TECHNICAL BULLETIN	
	December 1998 TB 1522
Mfg:	GM
Model:	C-SERIES
Liter:	6.5L
V I N:	F
Year:	92-00

Main Bearing Bolt Installation On
1992-97 GM 6.5L VIN F, S, & Y Engines

Bulletin Diagram: Untitled Graphic #2282 for TB 01522

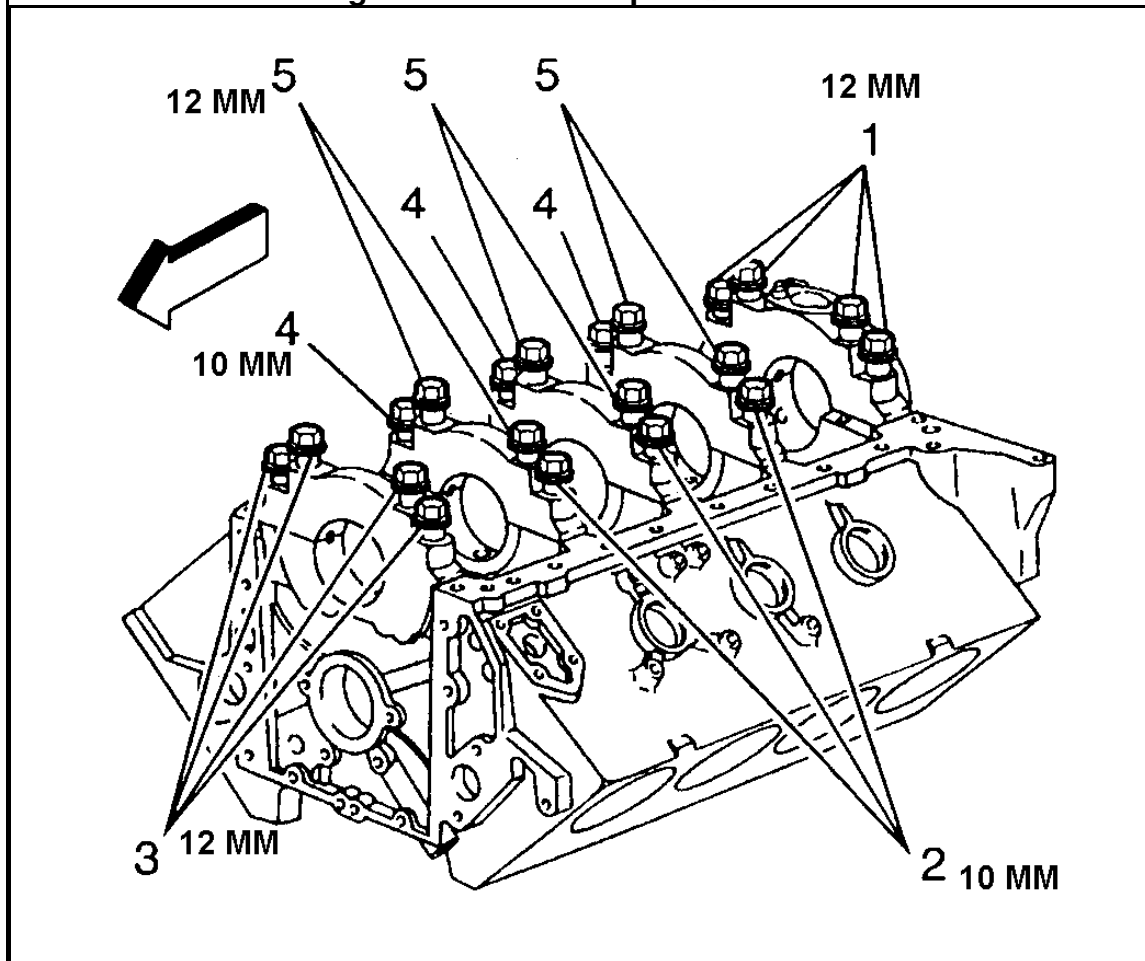
The AERA Technical Committee offers the following information on main bearing bolt installation on 1992-97 GM 6.5L VIN F, S & Y diesel engines. GM revised the outer, intermediate main bearing bolts beginning on March 13, 1997. At the above mentioned date the size of the 6 outer intermediate bolt holes was reduced from 12 mm, to 10 mm in size. With this revision, the installation procedure was also revised.

Determining which bolts are being used before assembly is advised to prevent over torque of the 10 mm bolts. All GM replacement engines will have the two different size bolt cap and should use the revised procedure listed above.

1. Install main caps 1,2,4 & 5 and inner 12mm lubricated bolts, torque mounting bolts to 55 ft. lbs.
 2. Install number 3 main cap (thrust) and inner 12mm lubricated bolts, torque mounting bolts to 10 ft. lbs. Move the crankshaft rearward and then forward to align thrust bearing surfaces.

3. Torque number 3 main cap inner bolts to 55 ft. lbs. Measure crankshaft end play in front of number 3 thrust bearing with crankshaft moved forward. Proper end clearance is .004-.010" (.10-.25mm).

4. Re-torque inner 12mm bolts to 55 ft/lbs. Then, turn inner 12 mm bolts an additional 90 degree turn.
 5. Torque outer 12mm lubricated cap bolts (numbers 1 & 5) to 48 ft. lbs.

6. Repeat step 5.
 7. Tighten the outer 12mm bolts (numbers 1 & 5) an additional 90 degree turn.
 8. Torque the outer 10mm lubricated cap bolts(numbers 2, 3 & 4) to 30 ft. lbs.

- CAUTION:** Do not rotate 10 mm bolts an additional 90 degree turn.
